E	ISSUE FOR SECTION 4.55	ISSUE FOR COORDINATION, SECTION 4.55 RESUBMISSION UPDATES, DA RESUBMISSION UPDATES	19/05/2025	CPA	RM	RM
ISSUE PURPOSE		Change Name	DATE	D.	C.	A.
SD

3 CENTRAL ROAD
3 CENTRAL ROAD, AVALON BEACH
CLIENT - AVALON CENTRAL PTY LTD
TITLE
FLOOR PLAN - ROOF
JOB No **5914**
DWG No **SD2010**
ISSUE **E**

FLOOR PLAN - GROUND FLOOR
SCALE 1:250 @ A3

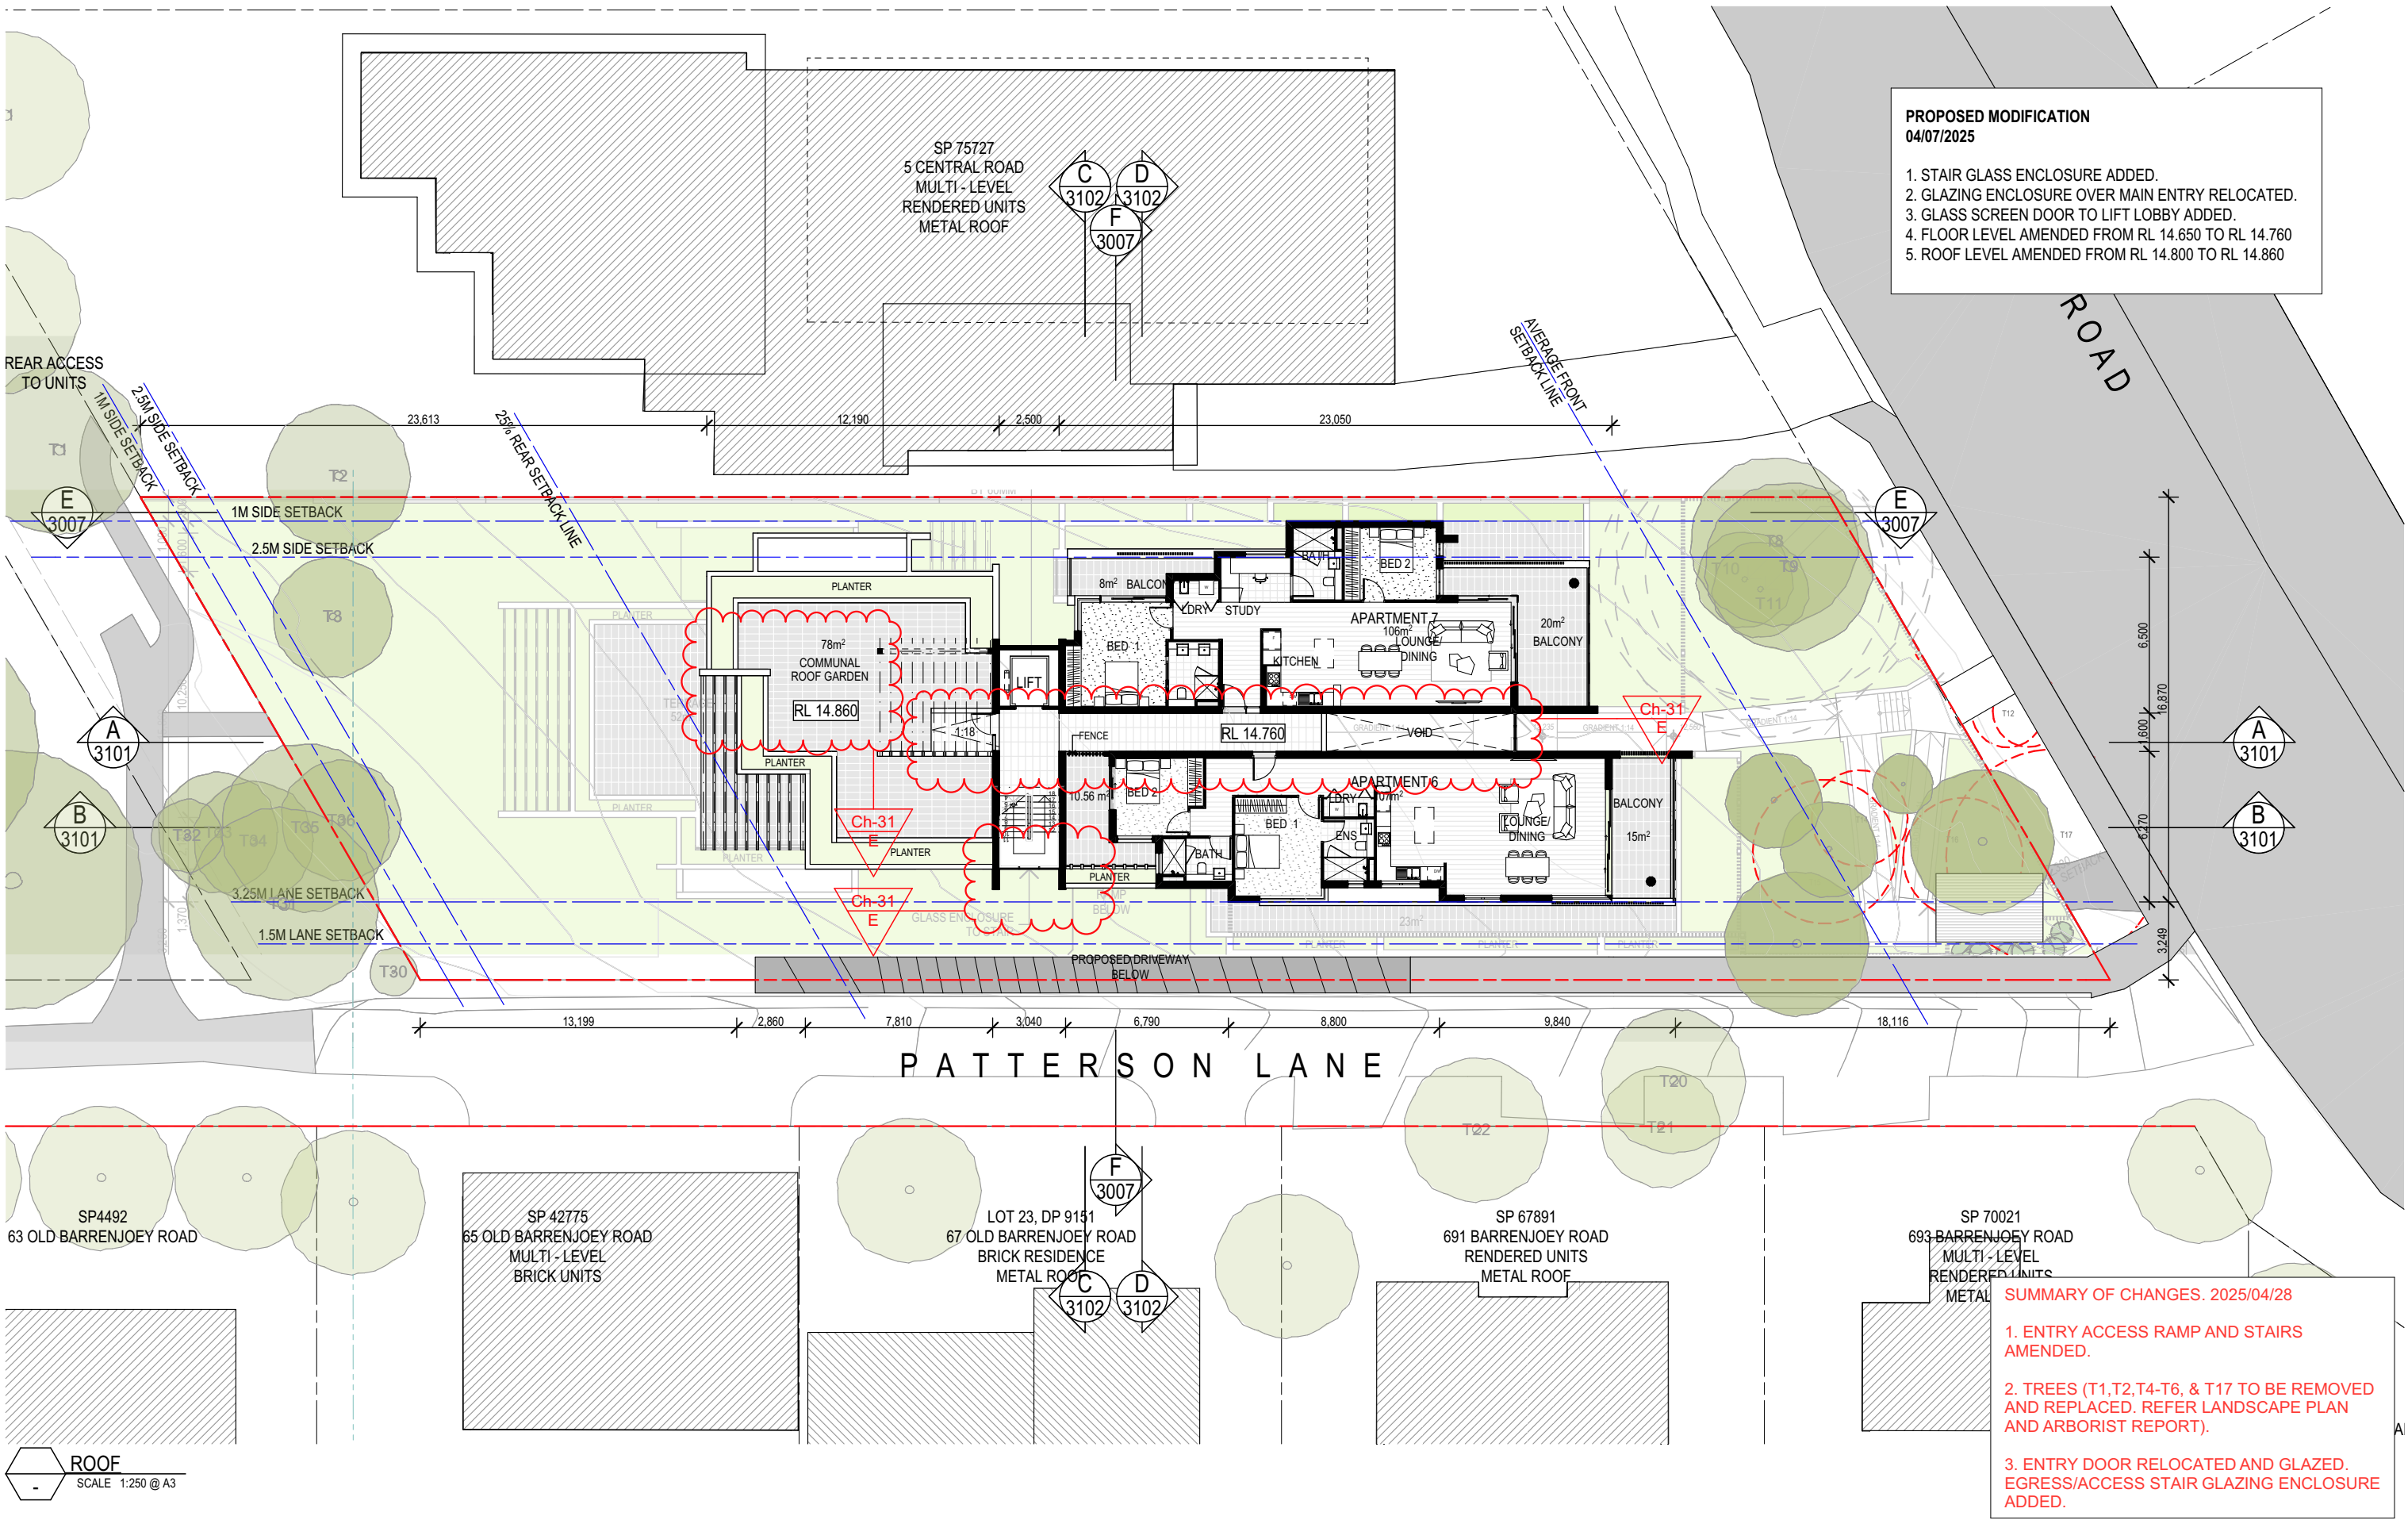
SUMMARY OF CHANGES. 2025/04/28

- ENTRY ACCESS RAMP AND STAIRS AMENDED.
- TREES (T1,T2,T4-T6, & T17 TO BE REMOVED AND REPLACED. REFER LANDSCAPE PLAN AND ARBORIST REPORT).
- ENTRY DOOR RELOCATED AND GLAZED. EGRESS/ACCESS STAIR GLAZING ENCLOSURE ADDED.

ROOF
SCALE 1:250 @ A3

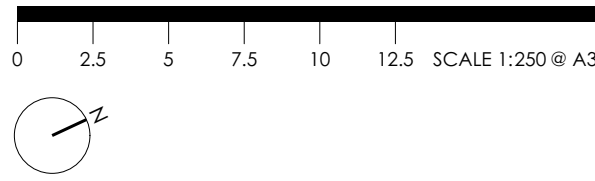
PROPOSED MODIFICATION
04/07/2025

1. CONCRETE ROOF SIMPLIFIED.
2. PERGOLA REPLACED WITH GLASS SKYLIGHT CUT OUT.
3. PARAPET HEIGHT AMENDED TO A SINGLE PERIMETER HEIGHT OF RL 18.05.
4. ALLOWANCE FOR CAR PARK EXHAUST DUCT.
5. ROOF SLAB LEVEL AMENDED FORM RL 17.700 TO RL 17.860

GFA & FSR SCHEDULE

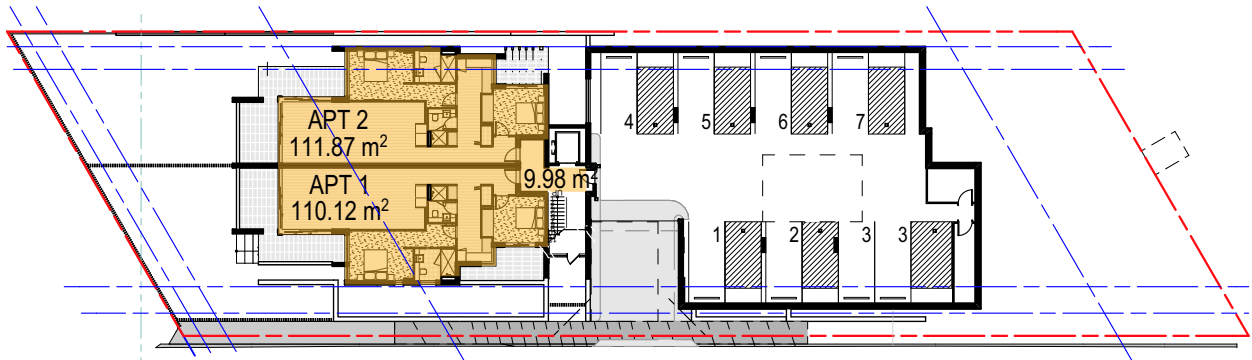
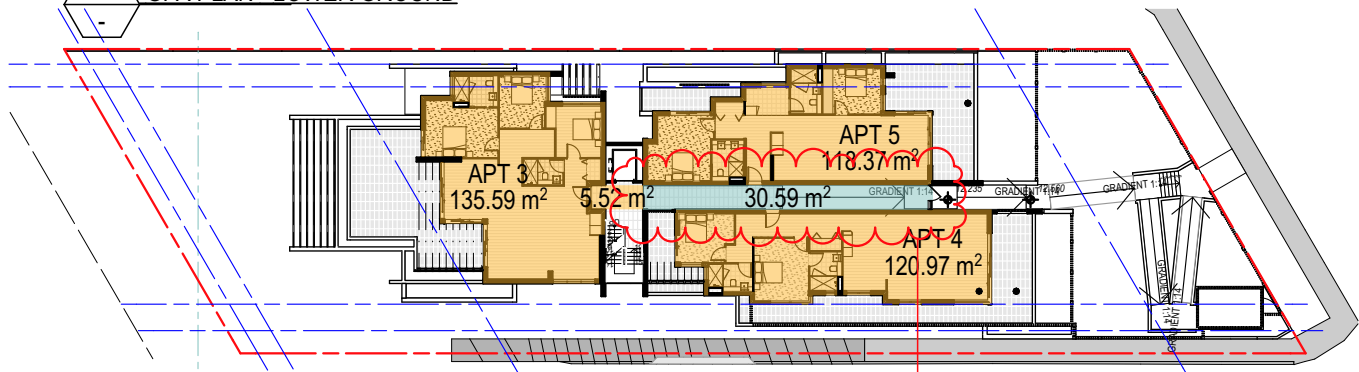
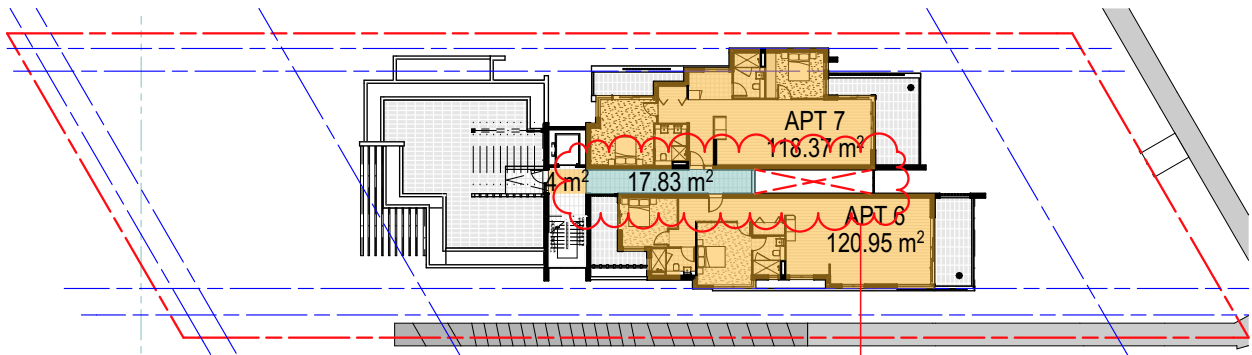
PROPOSED MODIFICATION
04/07/2025

1. ENCLOSED CORRIDOR ADDED TO GFA.
